Re: **Initial Submission Review** – Sterling Hills AMH – Site Plan and Plat
Application Number: **DA-1052-24**
Case Number: **2019-4014-00; 2019-3044-00**

Initial Submission Review

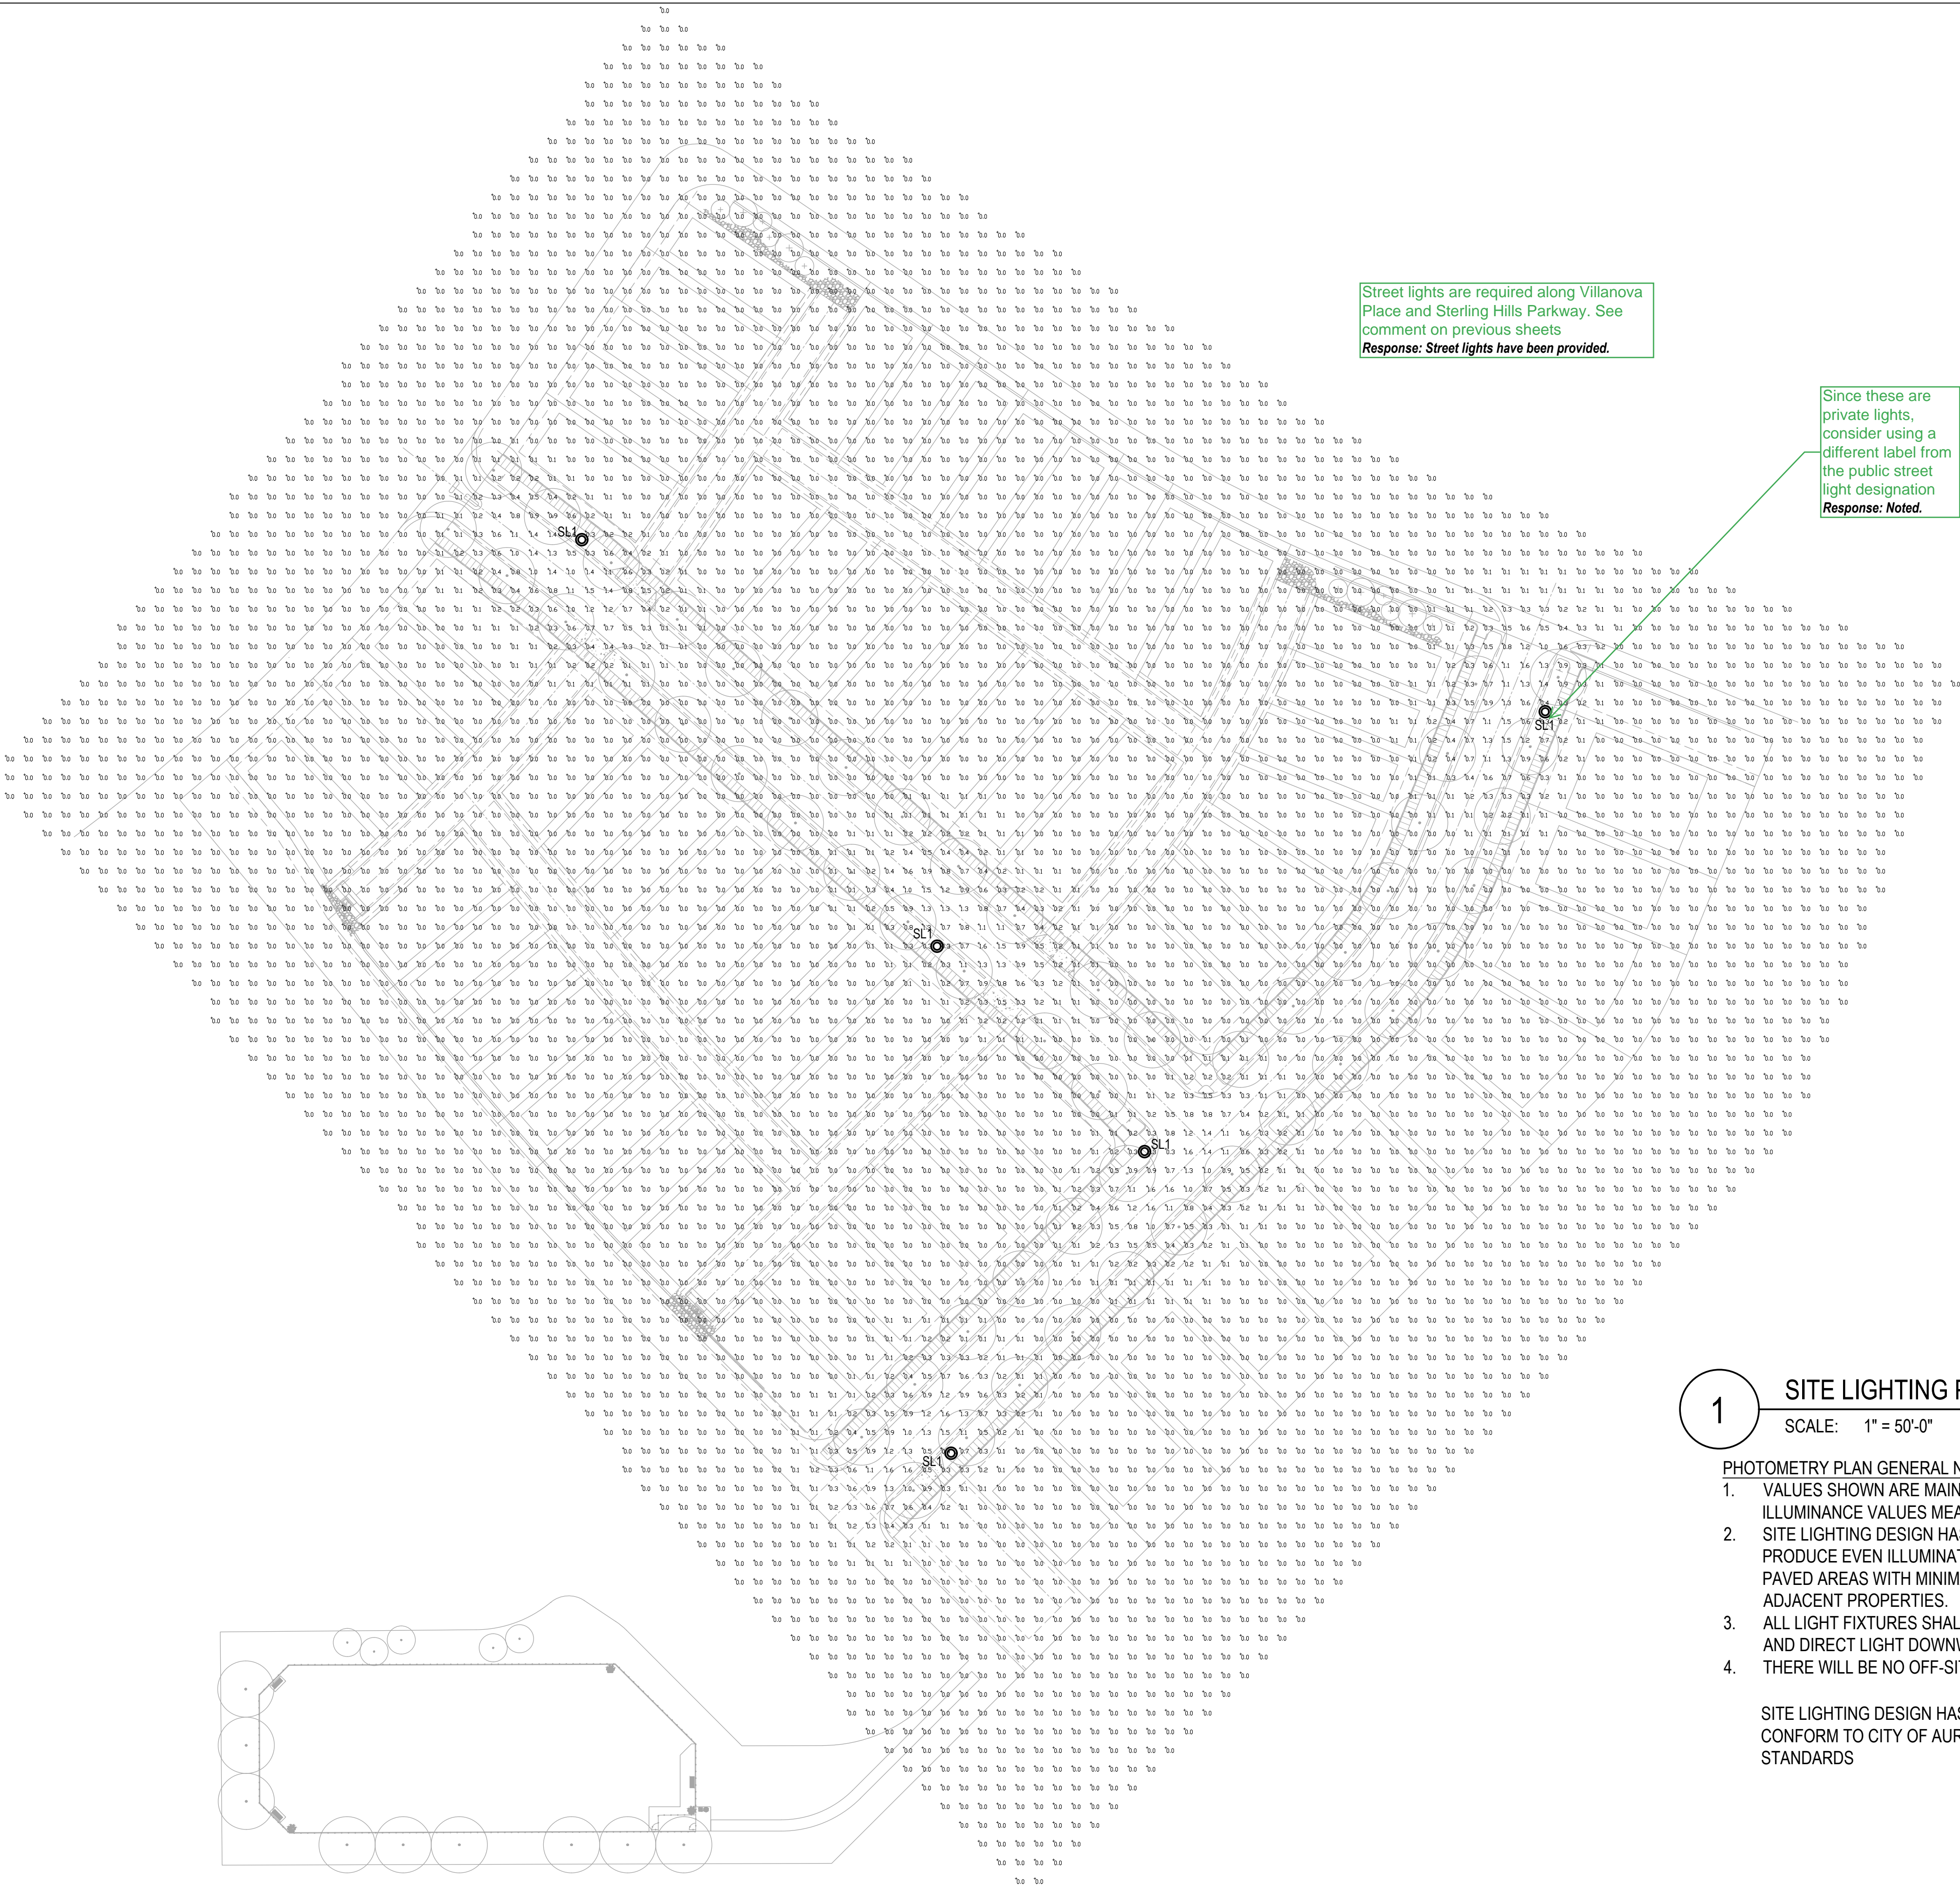
Street lights are required along Villanova Place and Sterling Hills Parkway. See comment on previous sheets
Response: Street lights have been provided.

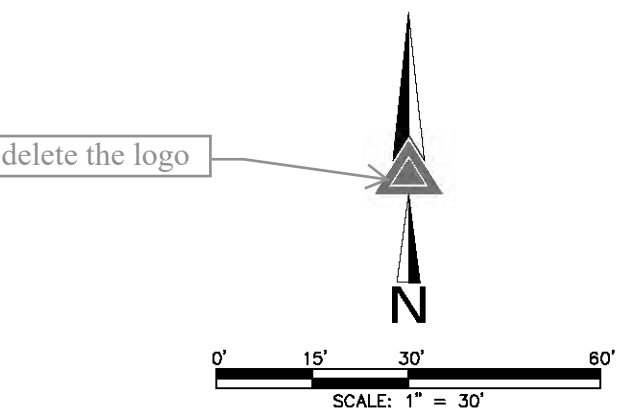
the subordinate distances should add up to match the overall distance for the same line length

DISTANCES NOW ADD UP

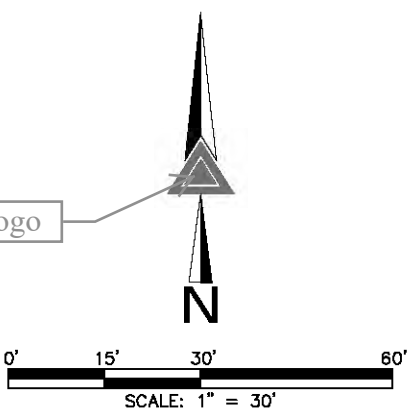
Private roads constructed to the COA Roadway
Designed and Construction standards are not
required to be dedicated fire lane easements.
Please revise by removing fire lane easement
labeling.

FIRE LANE EASEMENT
LABELING HAS BEEN
REMOVED
